GFA AIRWORTHINESS DIRECTIVE

- TYPE AFFECTED:** H-201 STD LIBELLE, H-201B STD LIBELLE,
H-202 SD LIBELLE, H301 LIBELLE, H-301B LIBELLE.
(German Type Cert No 251.)
- SERIAL No's Affected:** ALL

- SUBJECT:** Replacement of Rudder Gimbal Drive, rear actuator arm.
- BACKGROUND:** Damage, resulting in failure of the actuator arm, can be caused by improper lifting of the rear fuselage by the rudder, or following severe rear fuselage damage.

Technical Note
No. 301-39
No. 201-35

M 1:1	Ruderlenker	301-45-13	12.9.1986
				Skifjerner

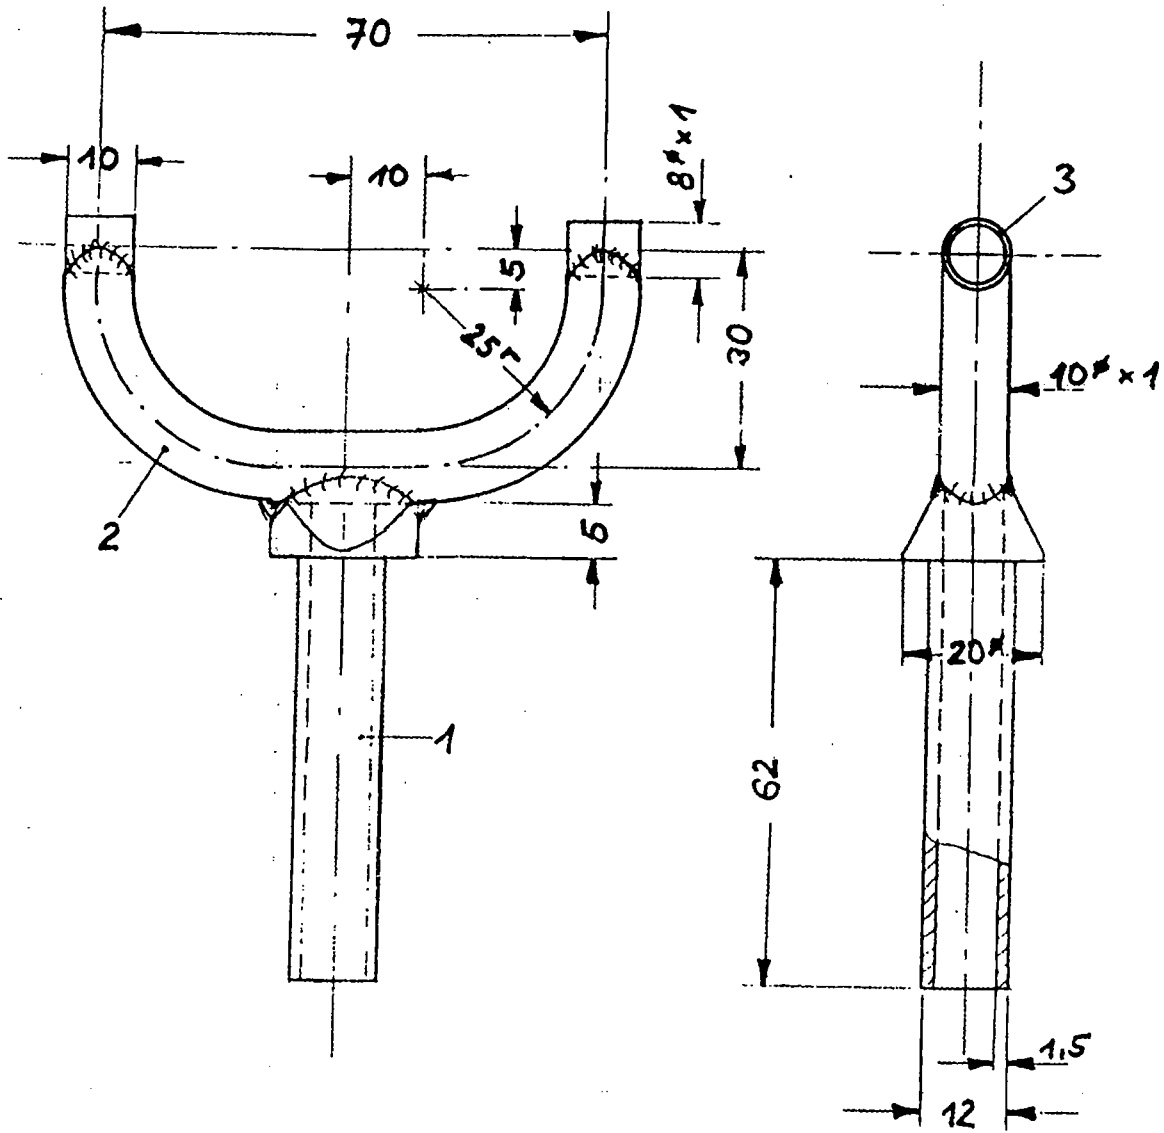
- ACTION REQUIRED:** In accordance with the above Technical Note replace the actuator arm type 301-45-10 with the improved version type 301-45-13.
- WEIGHT AND BALANCE:** Nil effect.

Only genuine parts made in accordance with drawing No. 301-45-13 must be used.

6. Re-attach rudder and tape it to fin when in proper position to avoid any aft movement.
7. Slide flange bushing on the actuator arm and secure in position by a wedge placed between bushing and cavity wall. Make sure that the bushings 4 mm holes are horizontal. Punch mark actuator arm on both sides at the center of the bushings 4.0 mm holes and drill arm to a diameter of 2.0 mm. With these holes properly aligned, drill to a diameter of 3.8 mm, then ream to 4.0 mm. If the 2.0 mm holes are not aligned, it is possible to use a round needle file for centering then drill and ream to proper diameter.
8. Insert locking bolt and secure with M4 stop nut.
